CHARRETTE OPTION ONE: TEST FIT - FULL BUILDOUT

CHARRETTE OPTION ONE: CONNECTIVITY AND OPEN SPACE

STUDY AREA A: OPTIONS

CHARRETTE OPTION TWO: CONNECTIVITY AND OPEN SPACE

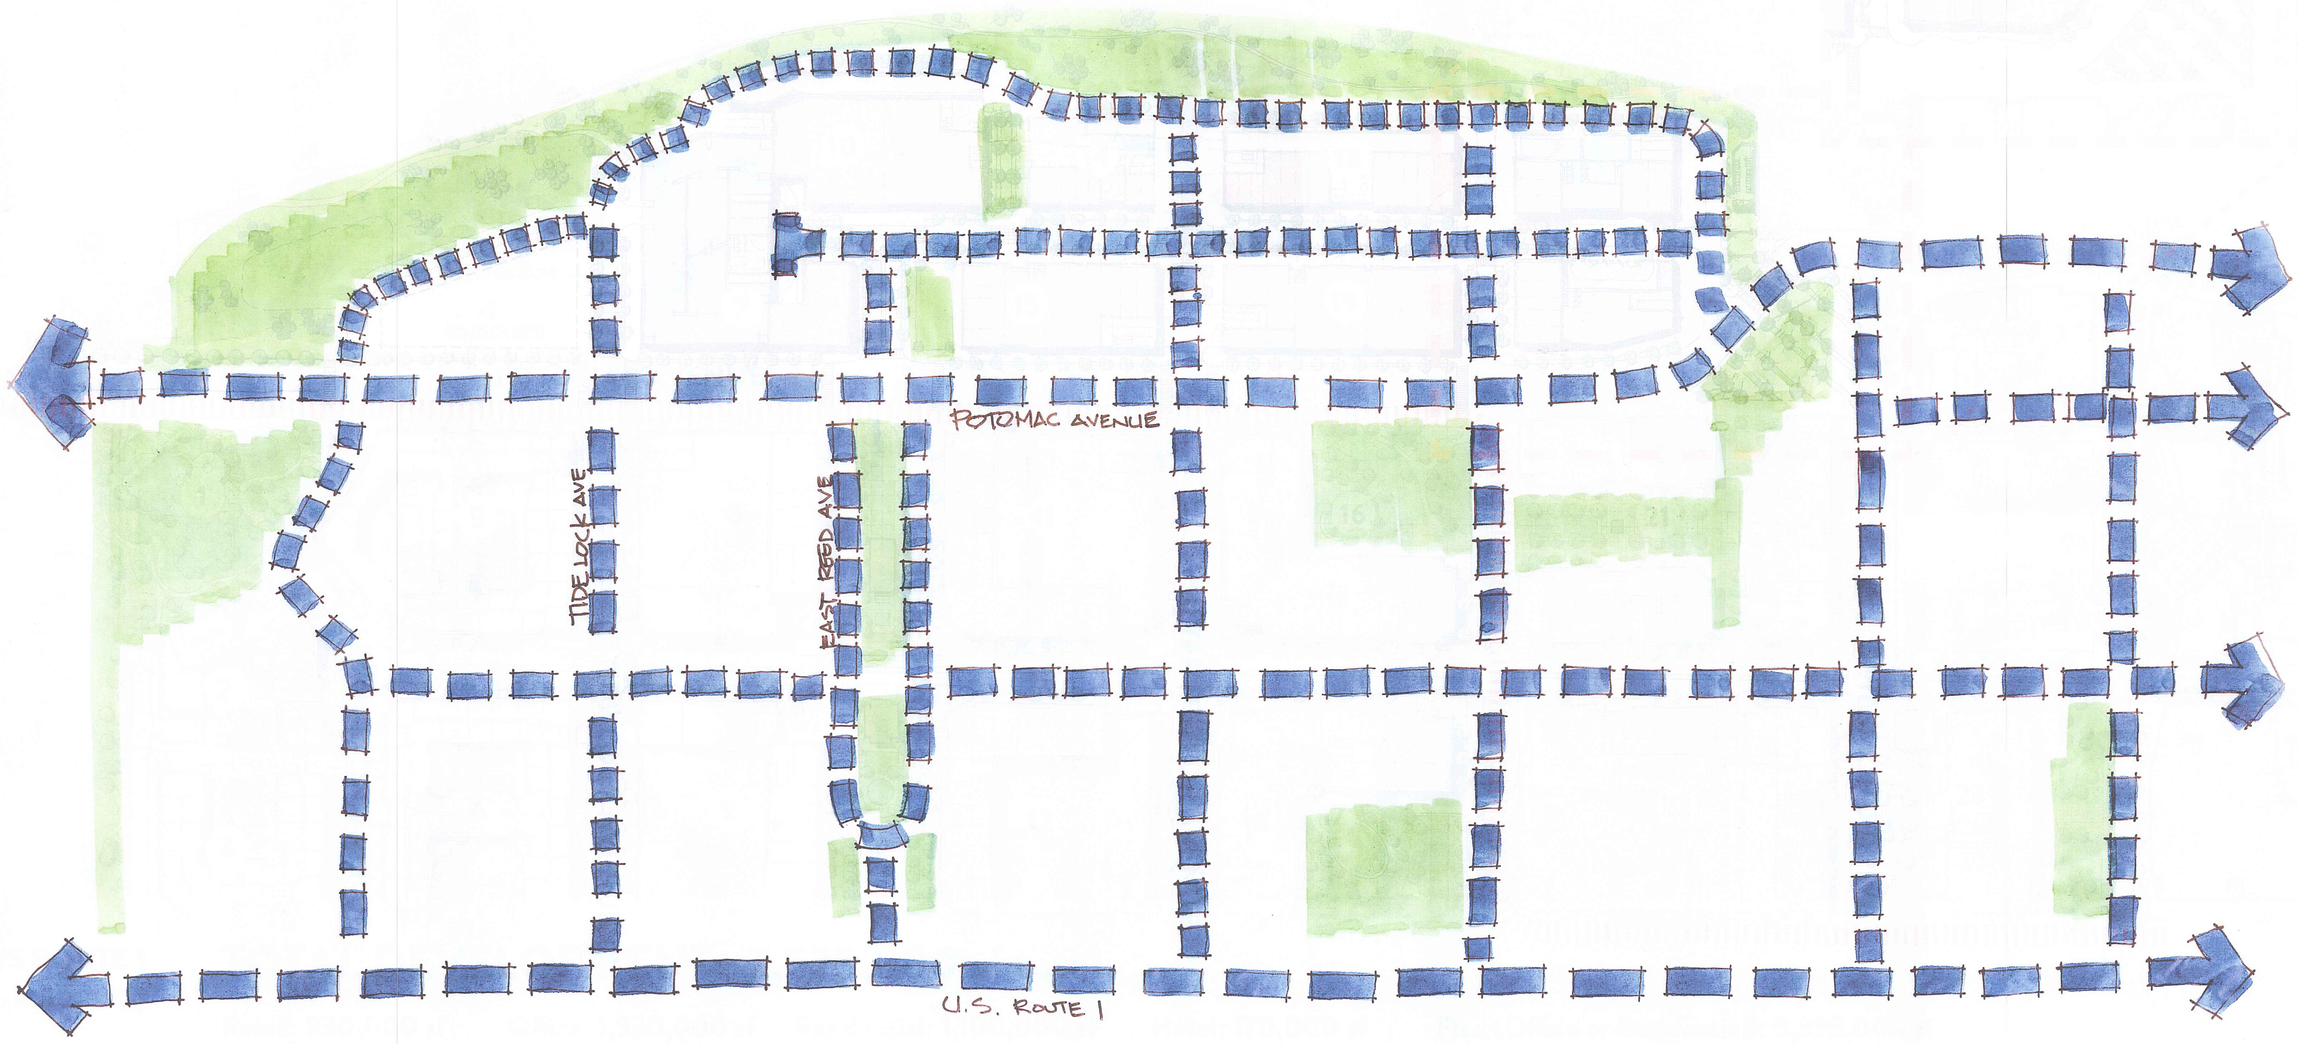
Needs some connection at 7 & 10 to small road, but not major boul too claustrophobic

I like the angled road on this option

Add angled road connection

Park Road
This Road Cars should be 2 way only
NOT STAY
No PARKING
150th STREET

Where this connection location of Potomac Ave. Adds more greenspace.

Shouldn't we Think - Less cars/traffic Travelling use of The Metro

Some walkable breaks would be desirable here

Right location for BRT.

CHARRETTE OPTION 1

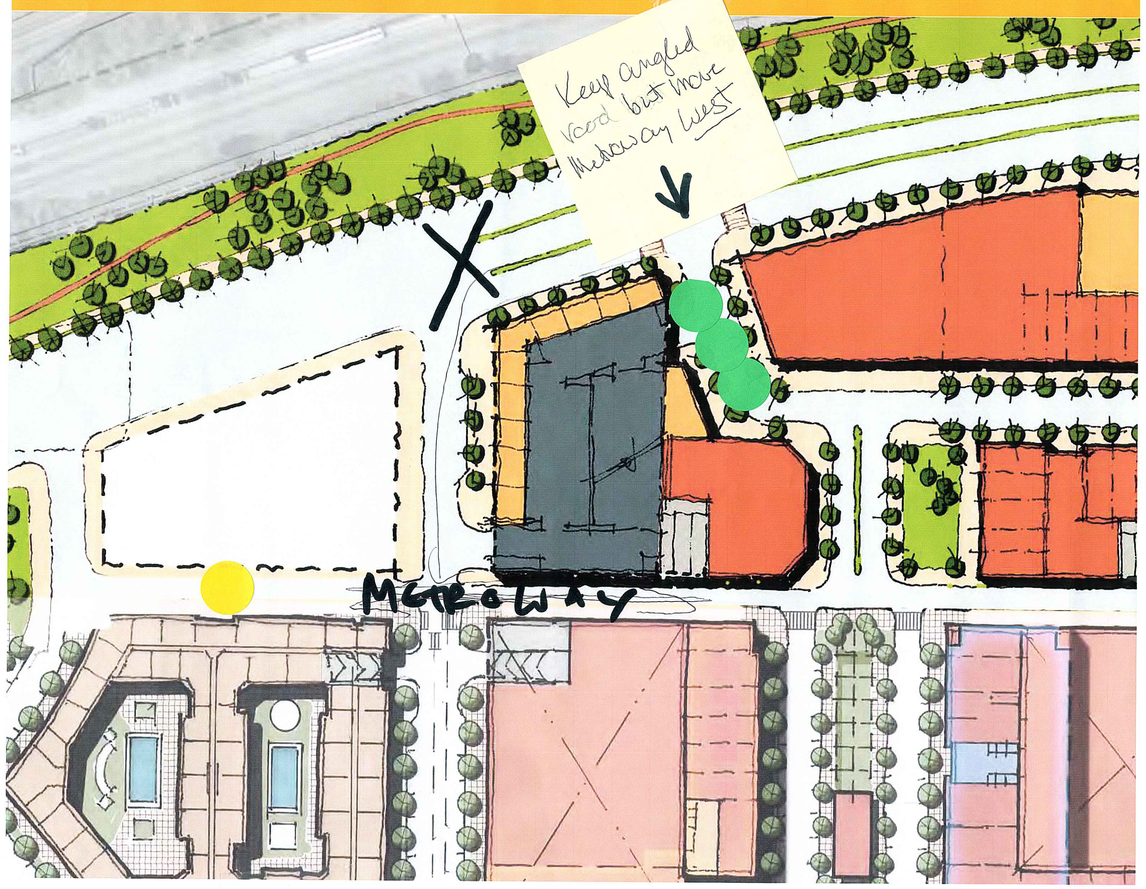
Too much breaking up s/t orchard garage

like through fare of Potomac Ave (Continuity of a parkway")

Too much separation b/w Park, Potomac Ave. + locating Ave makes park too small

Like this option but keep the angled road connection

like school drop off area & access to park for kids

like Reed Ave leading left to park/vista

Prefer overall layout, but parking garage may to be both up in some way

STUDY AREA C: POTOMAC AVENUE LOCATION

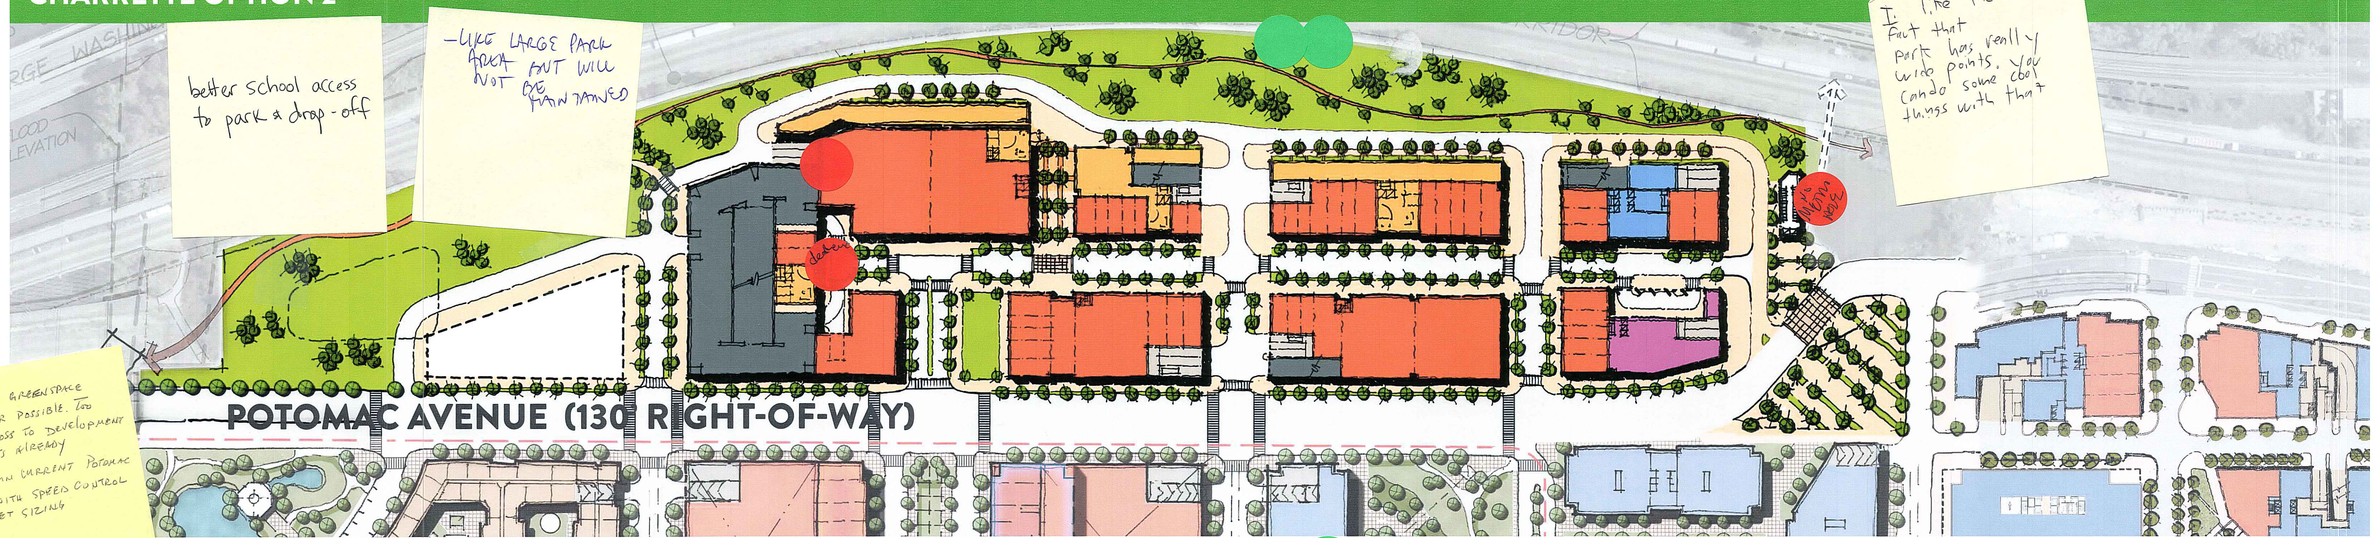
Metro north is better for Phase 1 retail - right?

Where are the fronts of buildings here?

Relatively similar park cross section = boring

Reed Ave lead to vista on park (Good)

- PARK FEELS MORE LIKE THE CONTINUATION OF EXISTING.
- LIKE THE PLEDRO PLAZA EASY TO RECOGNIZE

like wider park but also like Potomac Ave thruway along park

better school access to park & drop-off

-LIKE LARGE PARK AREA BUT WILL NOT BE PROGRAMMED

I like the fact that park has wide points, you can do some cool things with that

- MAINTAIN GREENSPACE WHEREVER POSSIBLE. TOO MUCH LOSS TO DEVELOPMENT PROJECTS ALREADY
- MAINTAIN CURRENT POTOMAC AVE WITH SPEED CONTROL STREET SIZING
